Subject: NPDES Permit Renewal
SMIP No. 6477SM5
Hamilton & Washington Townships
Adams and Franklin Counties

On behalf of Specialty Granules Inc (SGI), URS is responding to the Pennsylvania Department of Environmental Protection, (PADEP) comment letter dated July 13, 2012 concerning the NPDES Permit Renewal for the above referenced subject. This letter provides URS' response to PADEP's July 13, 2012 comment letter. The attached NPDES Permit No. PA0009059 Application Final Addendum Report dated October 25 is considered comprehensive and complete to address all of PADEP's comments on this matter, including the original PADEP comment letter dated April 25, 2012. The attached report replaces URS' prior response submittal dated May 24, 2012, as some calculations and conclusions have been revised to reflect the entire scope of comments received from PADEP.

NPDES PERMIT NO. PA0009059 APPLICATION FINAL ADDENDUM REPORT

**Charmian Facility
Hamiltonban Township,
Adams County, Pennsylvania**

JOB NO.: 20498083	SCALE: N.T.S.
SHEET: 9/24/12	REV.:
DRAWING NO.:	FIGURE 5

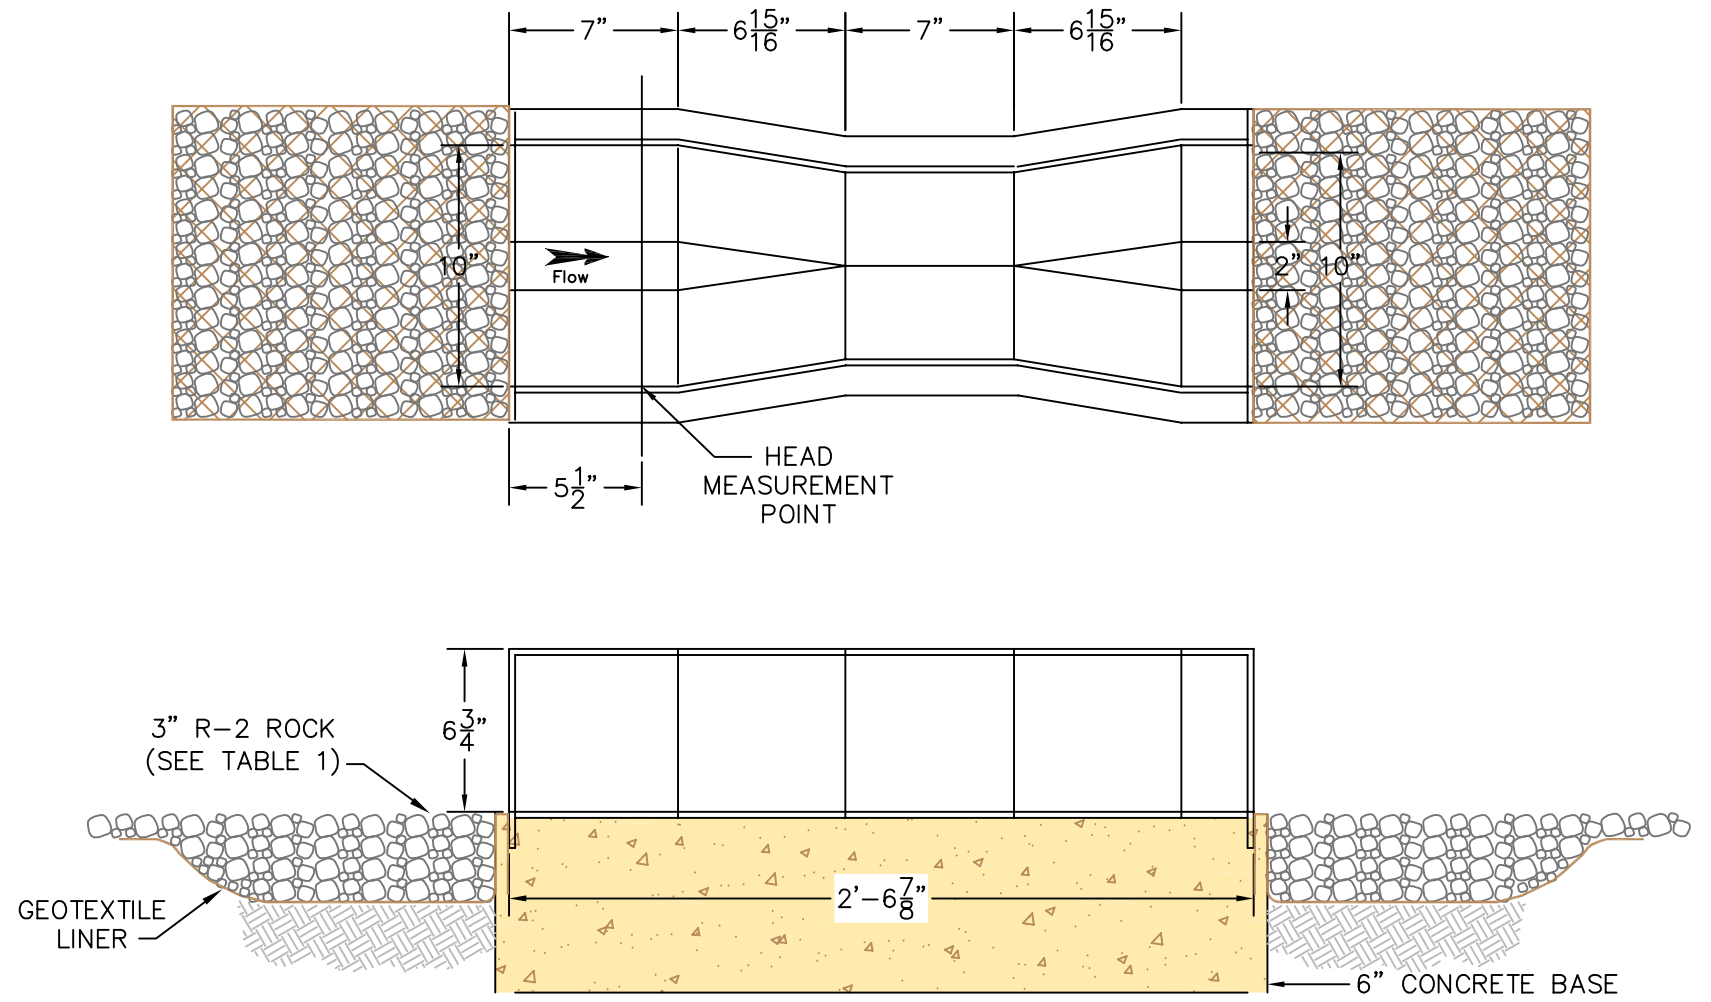
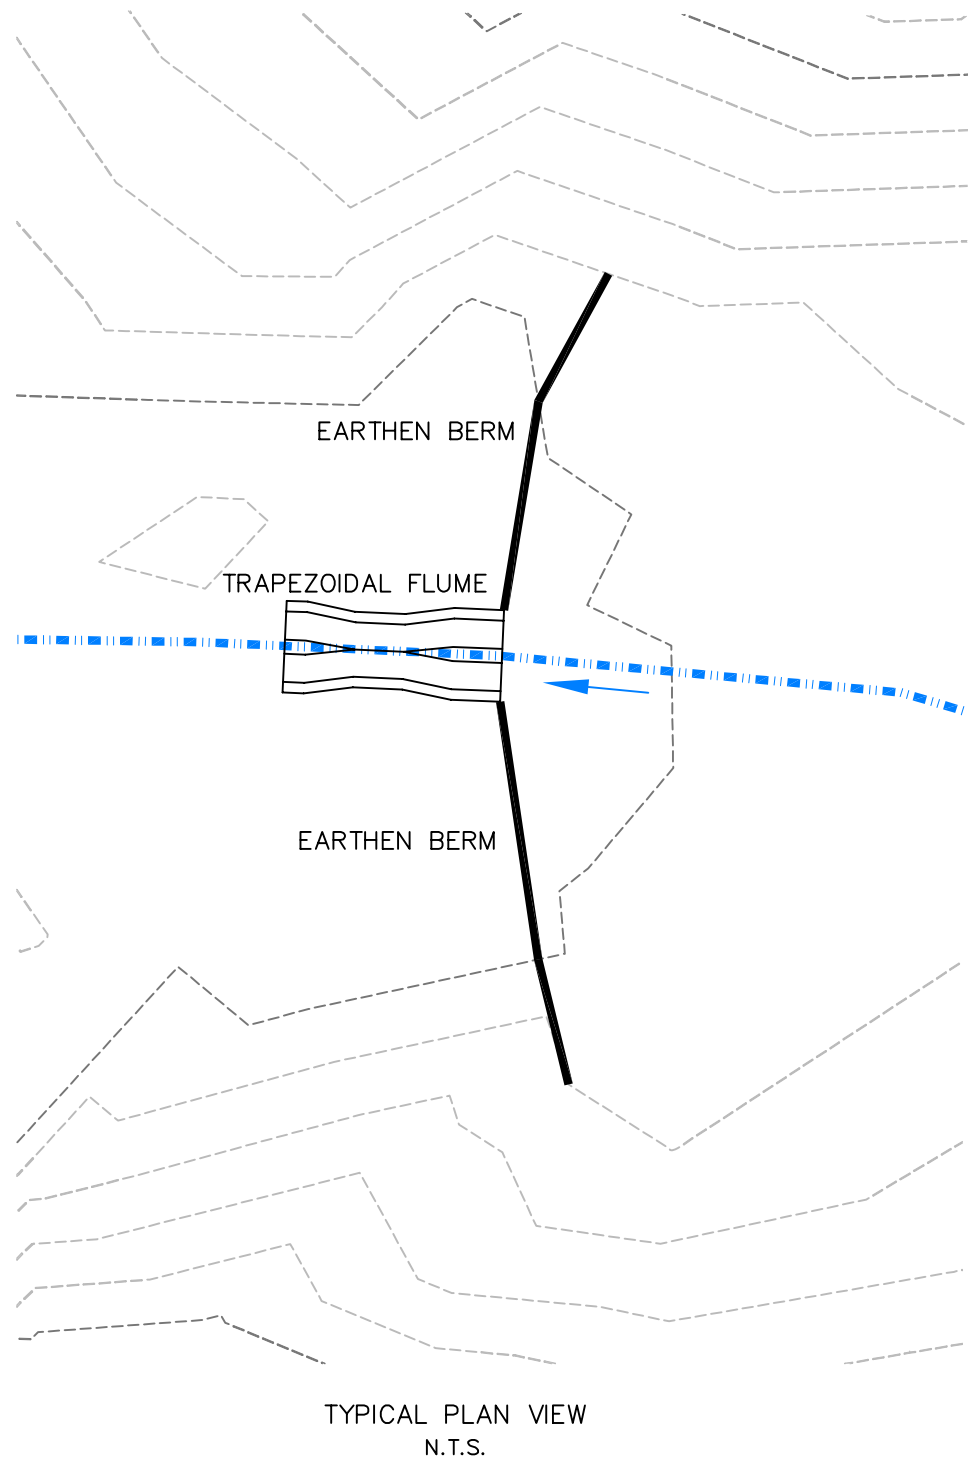
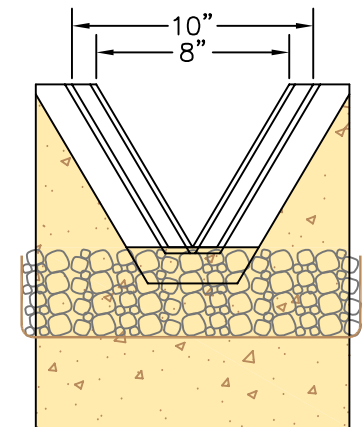
- 1.) Please construct weirs downstream of the Sediment Basin #3 outfalls. The one weir can help in the calibration of the proposed flow meter for Sediment Pond #3. The weir can provide a second check for the flow meter. However, if there is more than one discharge location for Sediment Basin #3 then all the discharges must be measured for the total outfall for Sediment Basin #3.
- 2.) Please clarify how long SGI personnel will have to wait to pump from the Pitts Quarry and Pitts Pond, after the peak flow has occurred at the Lower Mill natural drainage area. The Master Design Storm Summary, page 1.01 notes as the peak hours, 54.9, for the water to exit Pond 3. Is this the time that the SGI personnel will have to wait until they can pump from the other drainage areas?

SGI proposes to install three flumes, the locations of which are shown on Figure 4. The monitoring flumes (F-1 through F-3) will be constructed as shown on Figure 5, and will be sized according to maximum expected flow. These locations were chosen based upon observed discharge from the drainage layer through multiple site inspections conducted between July 2012 and October 2012 representing variable runoff conditions. Flume locations F-1 through F-3 will effectively measure the discharge from this drainage layer. Discharge will be measured daily and tracked for trends over time as a measure of determining the effectiveness of the drainage layer.
